March 1, 2019

Product Update: 2017-18 CR-V: Software Update with A/C Control Unit Replacement, DTC P0300, P0301, P0302, P0303, P0304, or P0172**AFFECTED VEHICLES**

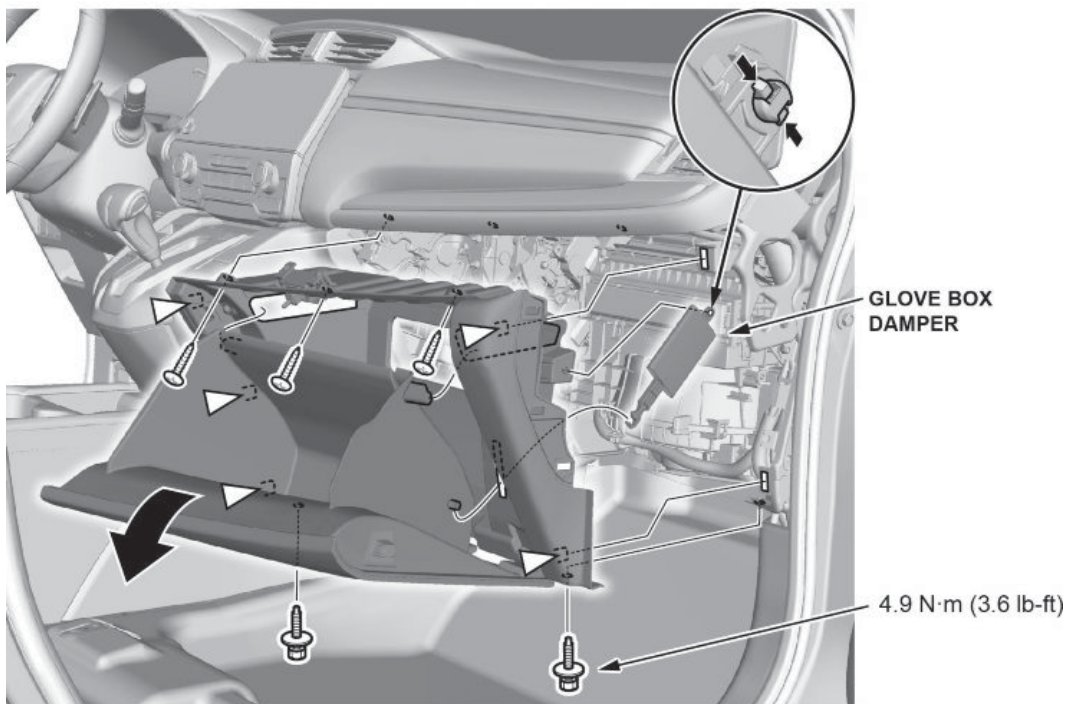
1. Reset maintenance minder main code A. Refer to the service information.
2. Drain and refill the engine oil. Do not replace the oil filter. (3.4 quarts)
3. Connect the i-HDS and click on the **Body Electrical**. From there, select **HVAC** and open **Data List/Snapshot** to check if the A/C control unit has been replaced. One of three options will appear; **Not Complete**, **Completed**, or **Not Applicable**.
 - If it reads Completed or Not Applicable, skip to step 5.
 - If it reads Not Complete, go to step 4.
4. Replace the A/C control unit.
 - 4.1. Remove the passenger's dashboard side lid and the dashboard undercover.

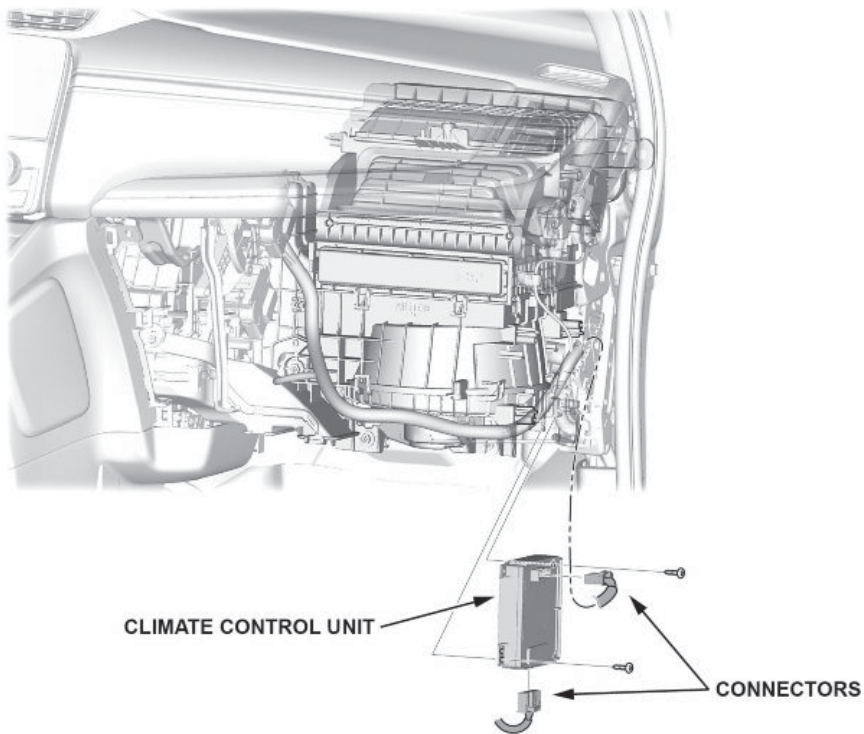
4.2. Remove the glove box.
